## HISTORIC AND DESIGN REVIEW COMMISSION

February 15, 2023

**HDRC CASE NO:** 2023-048  
**ADDRESS:** 322 N HACKBERRY STREET  
**LEGAL DESCRIPTION:** NCB 584 BLK W 1-2 7 LOT W 108.33 FT OF 6 ARB A8  
**ZONING:** RM-4, H  
**CITY COUNCIL DIST.:** 2  
**DISTRICT:** Dignowity Hill Historic District  
**APPLICANT:** Noe Garcia  
**OWNER:** Noe Garcia  
**TYPE OF WORK:** Siding Replacement  
**APPLICATION RECEIVED:** January 18, 2023  
**60-DAY REVIEW:** Not applicable due to City Council Emergency Orders  
**CASE MANAGER:** Bryan Morales

The applicant requests approval to replace all exterior wood siding with D105 wood siding.

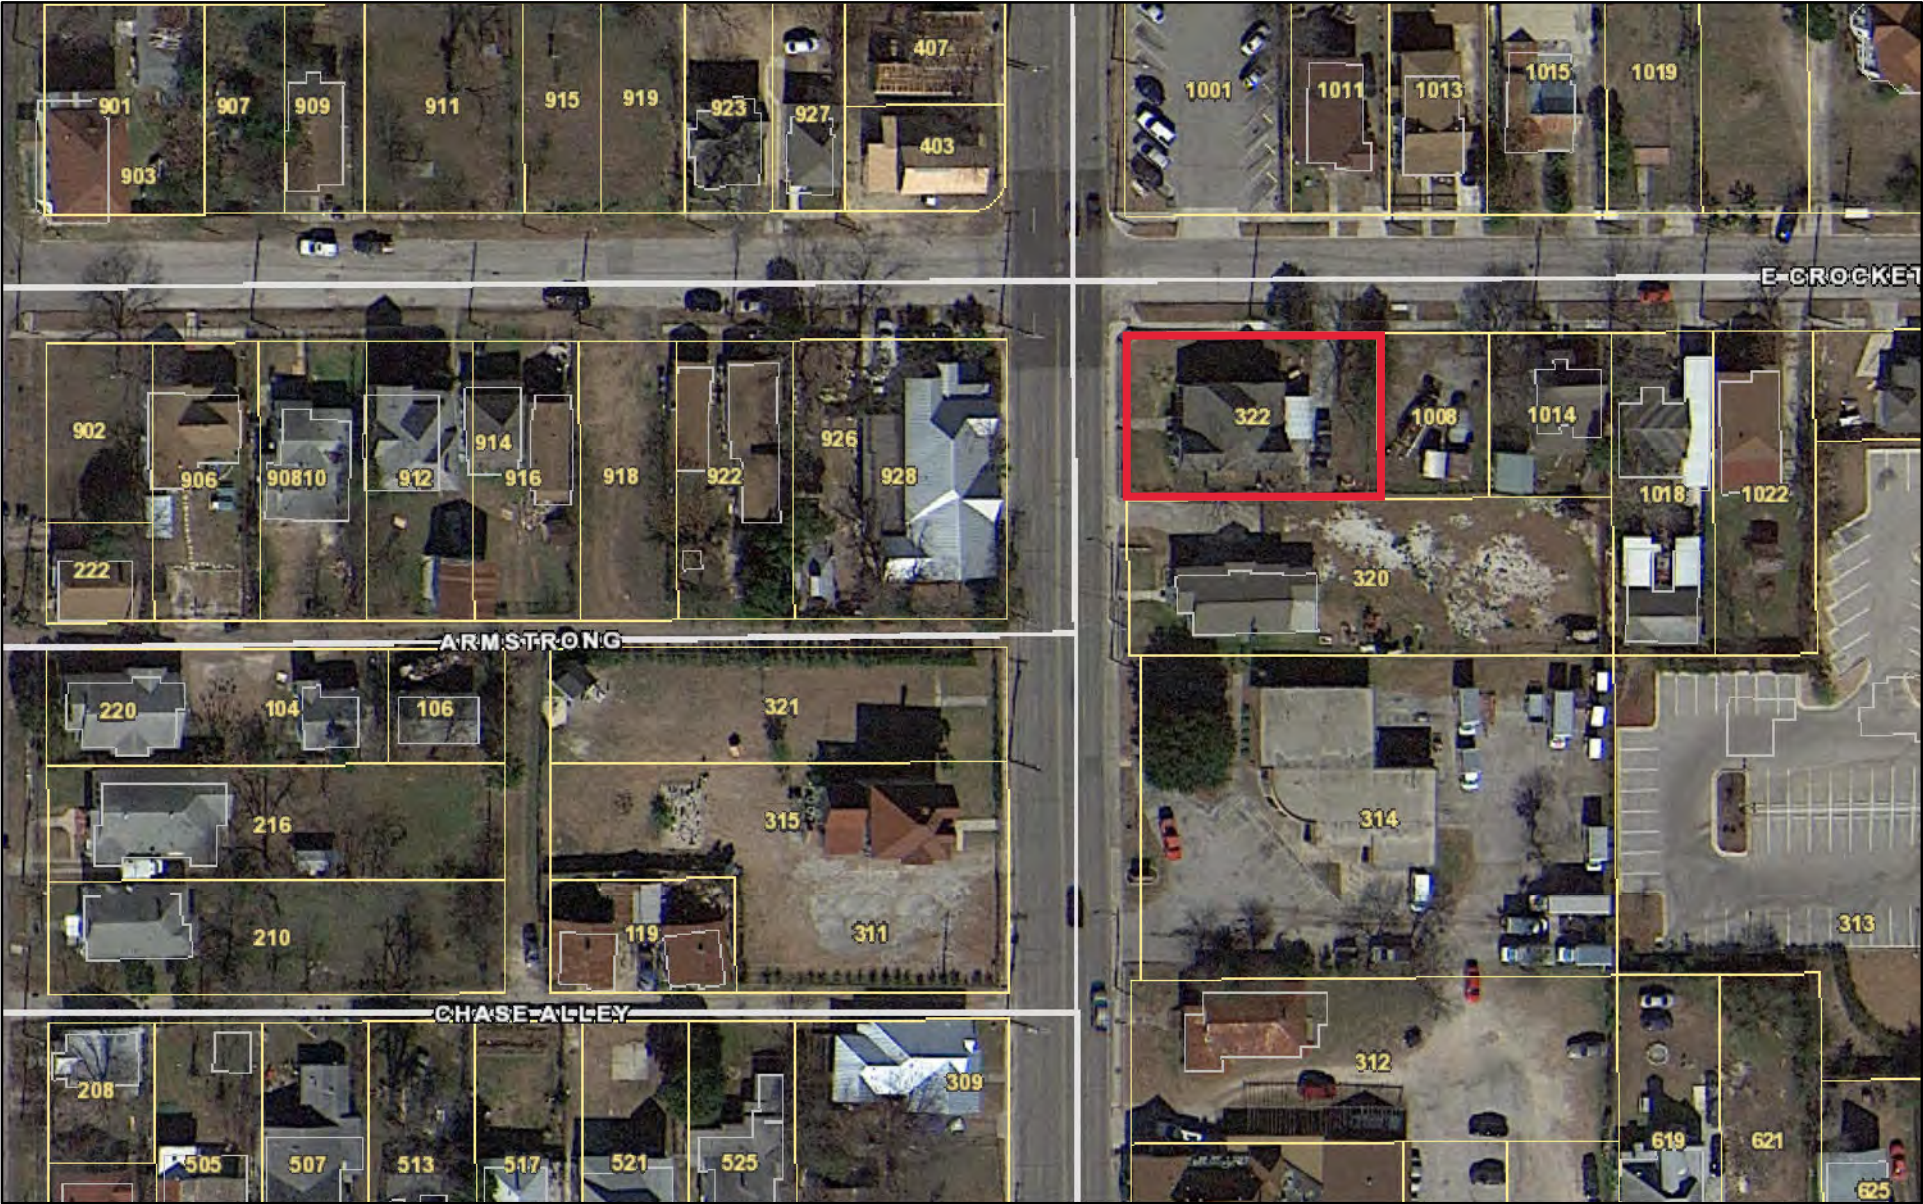
- c. VIOLATION: On January 17, 2023, staff observed the removal of the original siding. Staff advised the applicant that the wholesale removal of original siding was not consistent with the Guidelines.
- d. FAÇADE MODIFICATIONS (SIDING REPLACEMENT): The applicant has proposed to remove the original siding, which was a figured novelty profile with new, wood 105 profile siding. The original profile has been preserved on the front façade and the front bay, only. The Guidelines for Exterior Maintenance and Alterations 1.B.i. notes that façade materials that are in good condition should be repaired. When materials are beyond repair, they should be replaced in-kind. Staff finds the wholesale replacement of the original wood siding is not consistent with the Guidelines. In-kind, spot replacement as necessary is appropriate.

Staff does not recommend approval of the replacement of original wood siding with profile 105 siding, based on finding

- d. Staff recommends the applicant match the original profile.
